Technical Service Information

THM 4T60-E HARSH OR FIRM 3-4

Figure 1

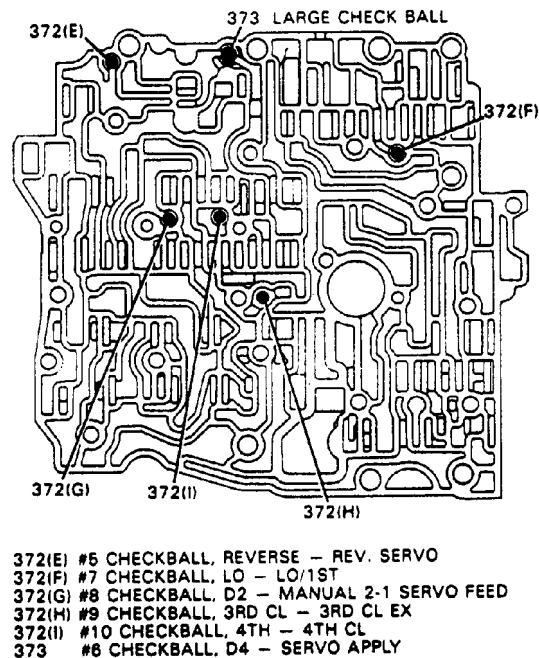
Also verify that the number 10 checkball in the valve body is not missing or off location (See Figure 1) , and that the 3-4 accumulator valve in the valve body is free and operational (See Figure 2).

Figure 3

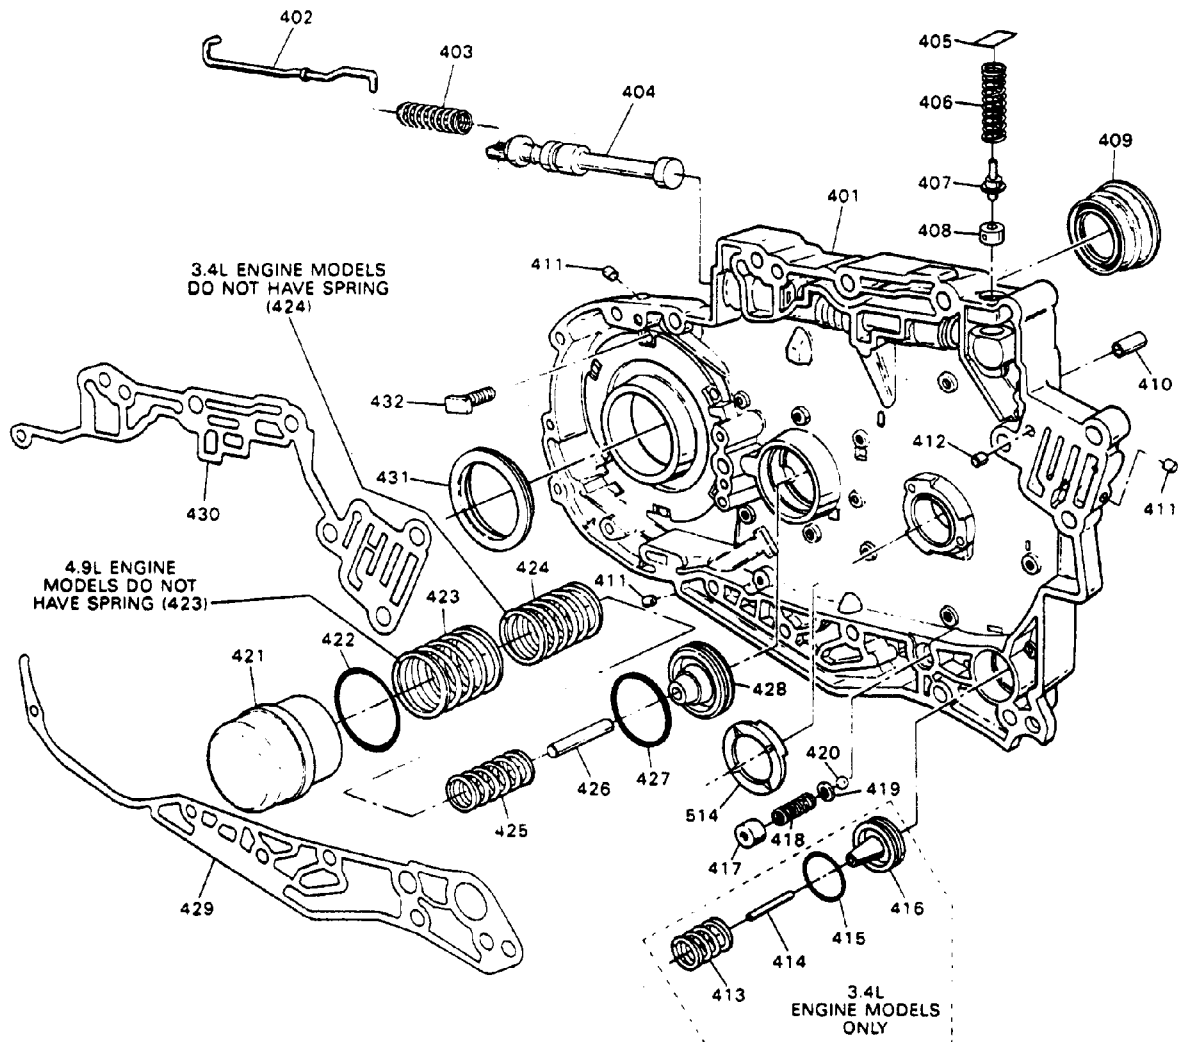
CAUSE: It has been determined that the third spring in the 3-4 accumulator canister may contribute to a harsh or firm 3-4 upshift (See Figure 3).

CORRECTION: Remove the channel plate and disassemble the 3-4 accumulator canister. If the 3-4 accumulator contains 3 springs, remove and discard the outer most (Largest Diameter) 3-4 accumulator spring (423) and re-assemble as shown in Figure 3.
